QUALITY ASSURANCE -- NON-CONFORMANCE REPORT

Location: Changxing Island, Shanghai, P.R. China**Report No:** NCR-000987**Prime Contractor:** American Bridge/Fluor Enterprises, a JV**Date:** 11-Mar-2011**Submitting Contractor:** Zhenhua Port Machinery Company, Ltd (ZPMC), Changxing Island**NCR #:** ZPMC-0945**Type of problem:**

Reference Description: QA found an UT indication after ZPMC had tested and accepted the weld in the Bikepath Cantilever Beam at PP113 (Lift 12)

Job Name: SAS Superstructure
Document No: 05.03.06-000944

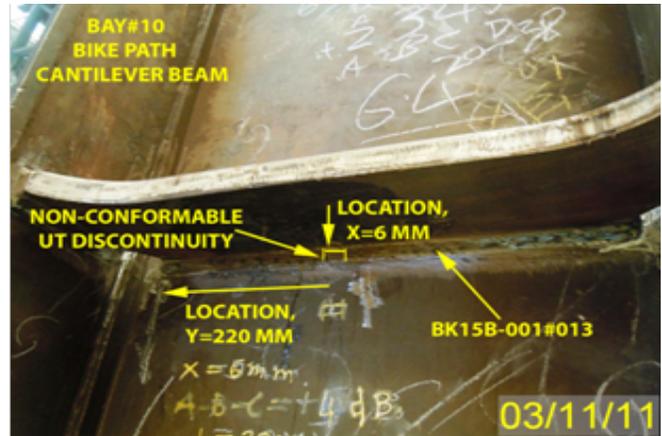
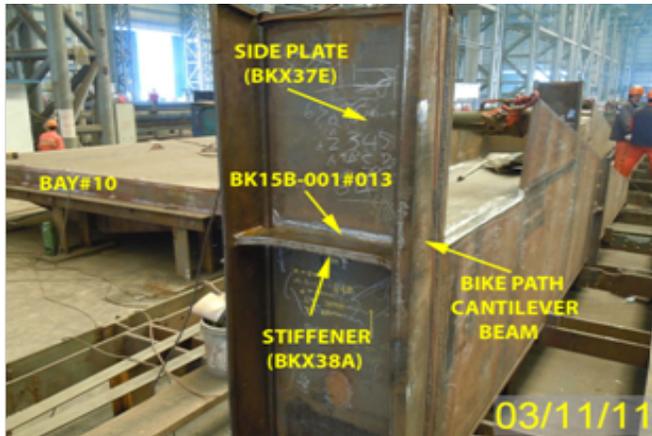
During the Ultrasonic Testing (UT) of bike path cantilever beam, this Quality Assurance Inspector discovered the following issue:

- One (1) Class "A" non conforming longitudinal indication in a weld.
- UT discontinuity rating was +4 db; Class "A" non-conformable indication.
- Depth of the discontinuity from face "B" is approximately 25 mm.

- Length of the discontinuity is approximately 25 mm in length.
- Y location is approximately 220 mm from left side of the joint.
- Weld is a double groove, complete joint penetration (CJP) T- joint, joining the side plate (BKX37E) to the stiffener (BKX38A).

- The weld is identified as BK15B-001-013.
- Scanning was performed from face "A" and "B" to cover the full volumetric scan of the weld.
- The material thickness is 32 mm.

- Component located at fabrication Bay#10.
- The Notice of Witness Inspection Number (NWIT) is 08509. The indication is located inside the area that has been previously tested and accepted by ZPMC Quality Control (QC) personnel. ZPMC's QC personnel performed 100% UT inspection of this weld.

Reference Resolution: ZPMC has repaired the indication noted in the NCR and is providing NDT documentation after the repair to show the indication has been removed.

This proposed resolution is acceptable. The documentation received is sufficient and the Department concurs that Non-Conformance ZPMC-0945 is closed.

Reference Description: QA found an UT indication after ZPMC had tested and accepted the weld in the Bikepath Cantilever Beam at PP113 (Lift 12)

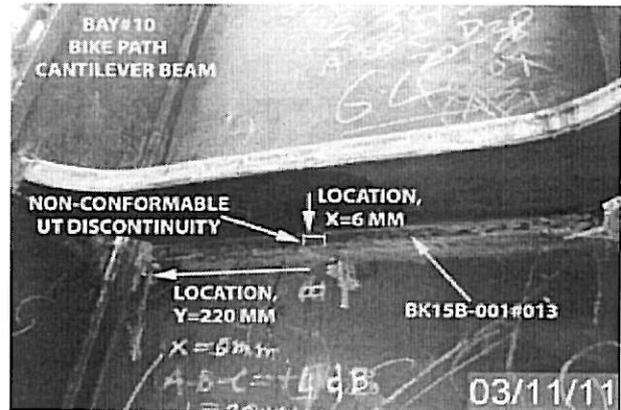
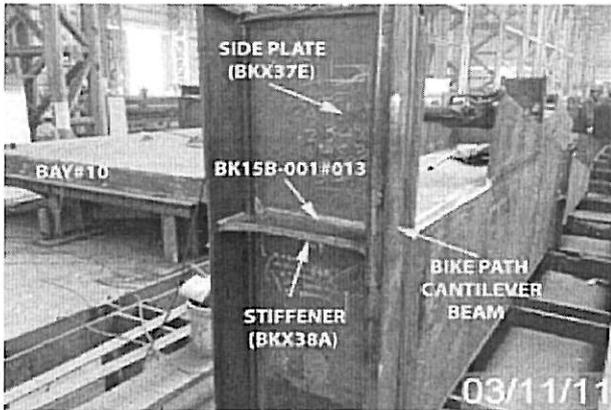
During the Ultrasonic Testing (UT) of bike path cantilever beam, this Quality Assurance Inspector discovered the following issue:

- One (1) Class "A" non conforming longitudinal indication in a weld.
- UT discontinuity rating was +4 db; Class "A" non-conformable indication.
- Depth of the discontinuity from face "B" is approximately 25 mm.

- Length of the discontinuity is approximately 25 mm in length.
- Y location is approximately 220 mm from left side of the joint.
- Weld is a double groove, complete joint penetration (CJP) T- joint, joining the side plate (BKX37E) to the stiffener (BKX38A).

- The weld is identified as BK15B-001-013.
- Scanning was performed from face "A" and "B" to cover the full volumetric scan of the weld.
- The material thickness is 32 mm.

- Component located at fabrication Bay#10.
- The Notice of Witness Inspection Number (NWIT) is 08509. The indication is located inside the area that has been previously tested and accepted by ZPMC Quality Control (QC) personnel. ZPMC's QC personnel performed 100% UT inspection of this weld.

Contractor repaired the weld. NDT report was provided showing the weld is acceptable. ZPMC identified the inspector and issued internal NCR. The inspector's performance is being monitored.

焊缝编号为： BK15B-001-013

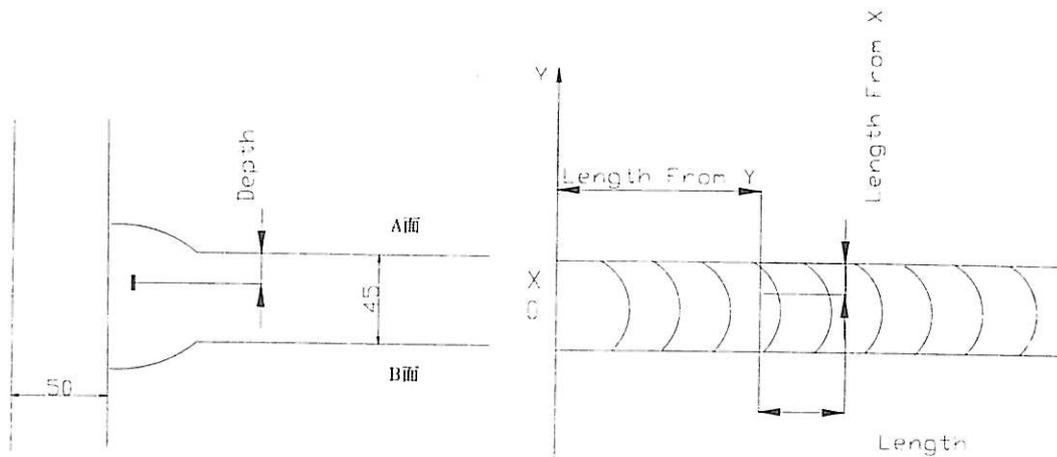
焊缝缺陷描述：(普通UT探伤发现的缺陷长度小于最大允许长度)

(Description of welding discontinuity): Rejected indication found by ultrasonic inspection is less than the maximum allowance aggregate length.

1. 焊道未及时处理干净。
1. Did not clear the weld pass completely in time.

1. 从缺陷距离端面较近一侧 ($D \leq 0.65T$, D为缺陷深度, T为板厚) 采用碳刨或打磨的方法去除焊缝缺陷;
2. 参照返修焊接工艺规程(WPS)准备正确的接头型式, 预热和焊接;
3. 将修补区域打磨到与母材或邻近焊缝平齐;
4. 根据批准的车间图纸检查焊缝.

1. Gouge or grind from nearer side from metal edge ($D \leq 0.65T$, "D" is depth of defects, "T" is thickness of metal) to remove all defects;
2. Follow repair WPS for joint preparation, preheat, and weld deposit;
3. Grind the repaired area flush with base metal or the adjacent weld;
4. Check the welds according to the working drawings.
